INFORMATION BULLETIN

No.004

SUBJECT : **NEW POWER DISTRIBUTION BOX**

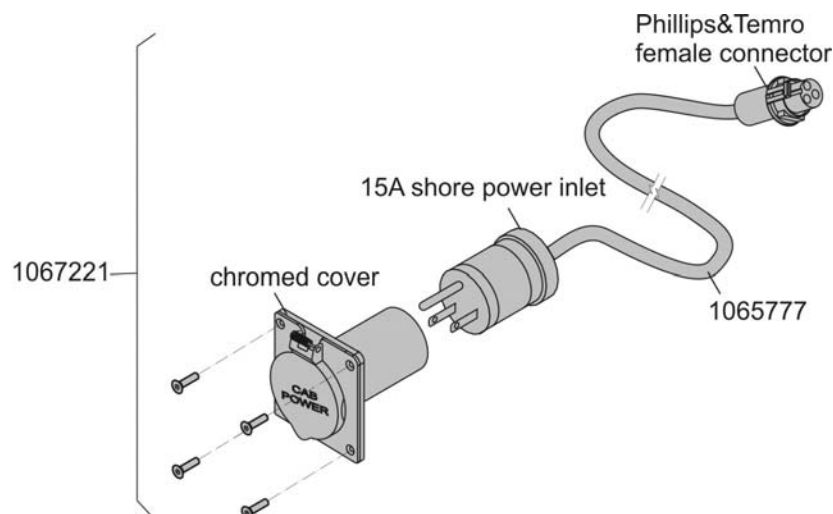
Existing SHORE POWER DISTRIBUTION BOX P/N 1060859 with hard wired 30A shore power inlet is being replaced by **NEW SHORE POWER DISTRIBUTION BOX P/N 1065565**.

The new box uses a Phillips & Temro type connector that is the industry standard, this will allow use of factory option shore power inlet on some trucks (Volvo, International...) and will simplify installation by avoiding necessity of using 15A/30A adapter and installation of separate internal outlet.

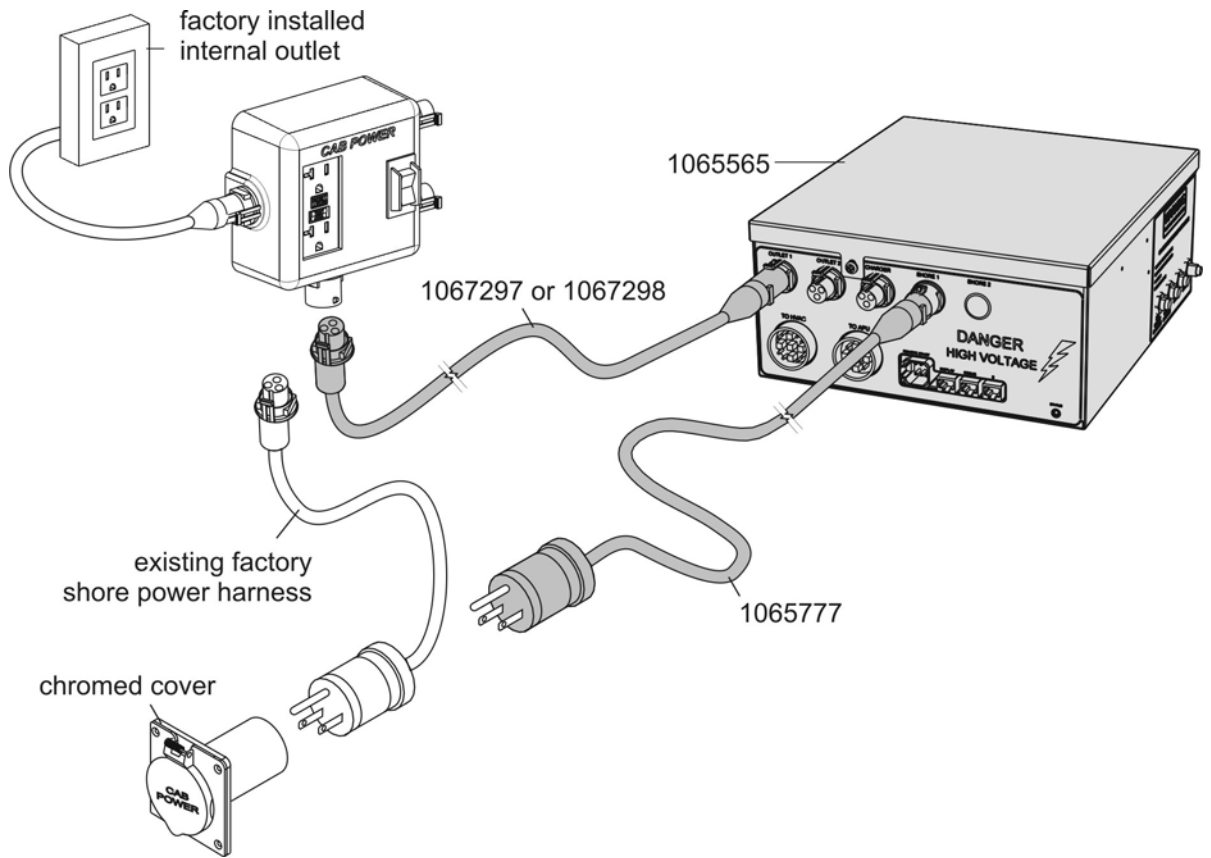
NEW SHORE POWER DISTRIBUTION BOX P/N 1065565 can accept shore power inlet that is already installed on the truck from factory (check existing harness length whether it will reach to the intended power distribution box location) or can be used in conjunction with following parts:

- when 1065777 harness is too short
- when existing factory shore power harness is too short
- to connect existing factory installed **internal outlets** (CabPower from Phillips&Temro) to the new power distribution box (see image above).
